**6625A-11**

# S E R V I C E N O T E

## 6625A DC Power Supply

### Intermittent Power Transformer “Magma” Connections

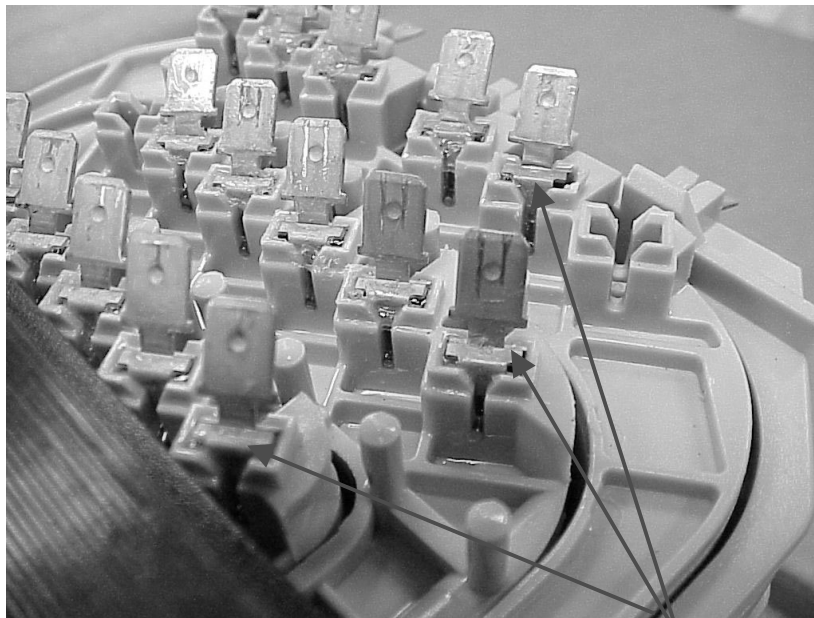
The power transformer vendor mistakenly installed the wrong “Magmates” in a run of power transformers. The incorrect “Magmates” have a # 43 stamped on them, which corresponds to a 15 gauge wire size. The correct size “Magma” should be # 24 designed for a 19 gauge wire size.

This could result in a variety of intermittent as well as steady hardware problems and errors. Examples: HDW ERR CH 1, Blank front panel display, not meeting specifications.

Replace the Power Transformer with a new replacement Transformer, see the table above for the correct power transformer part number.

**NOTE:** Please inspect the new transformer for the correct “Magma” number stamping.

**Top View of Power Transformer:**

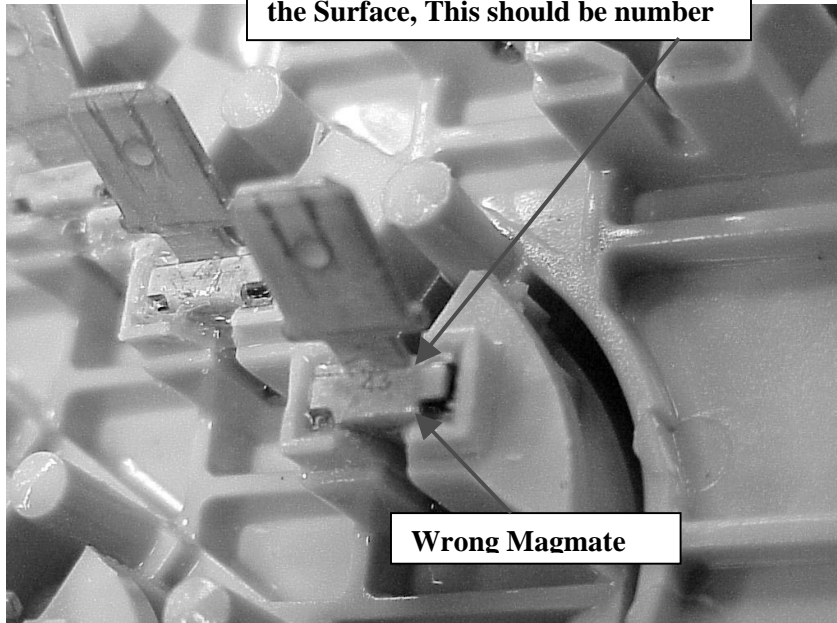
**Incorrect “Magma” number 43 on the Surface, This should be number**

**Wrong Magma**
